City of Portland, Maine - Building or Use Permit Application
 389 Congress Street, 04101 Tel: (207) 874-8703, Fax: (207) 874-8716

| Past Use: Single Family | Proposed Use: Single Family / Attic conversion to master Bedroom & bathroom w/construction of 3rd dormer on back of roof. | Permit Fee: \$174.00 | Cost of Work: \$25,000.00 | CEO District: 2 |

Re: Building Permit 10530 for Interior Renovation Third Floor to Master Bedroom
at 34 Codman Street / CBL 129-H-10

Re: Permit # 01-530/

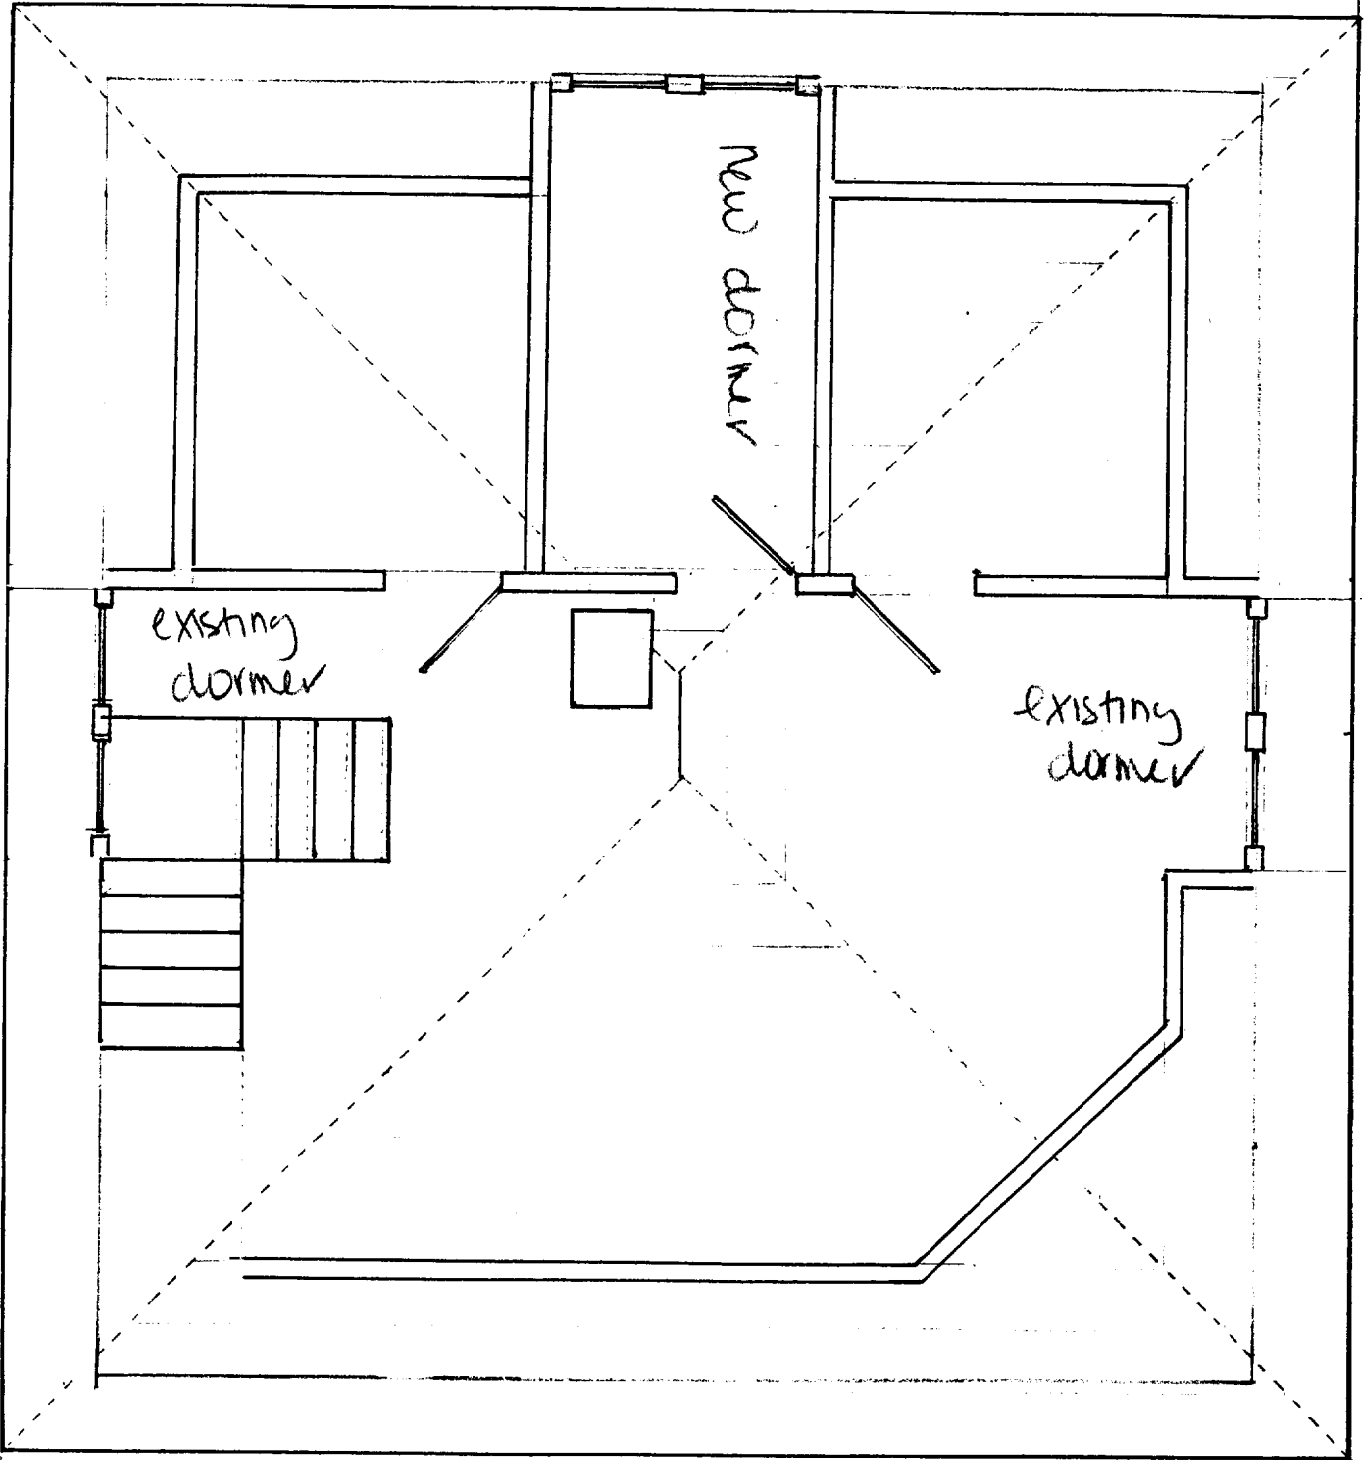
Headroom issue @ stairs to 3rd fl. See Indicated measurements on plans.

Owner to seek waiver from 80" headroom requirement. NO stairs to 3rd fl. do not meet code

Please find enclosed a drawing that shows the one rafter that poses the problem and some photos that depict the area. Please note that the drawing is on a 1:12 scale and shows the dimensions from the point of view of the stairway landing. I am sure that you will let me know if there are other measurements that you need; and, if so, I will be happy to provide them as necessary for you to make a determination. I also ask that you consider the following points:

- As you will see from the drawing, the headroom between the landing and the rafter on the lefthand side of the stairway (as you descend) exceeds the minimum requirements by two inches. The foot traffic will obviously be on this side of the stairway.

- 1) The proposed alteration of the space to sleeping space will comply with all other applicable provisions of the code including Egress Window standards and Smoke Detection.
- 2) Modification of the stairway to meet 80" throughout the stairway would create undue hardship.
- 3) The waiver is hereby granted pursuant to Section 121.1 of the Code.
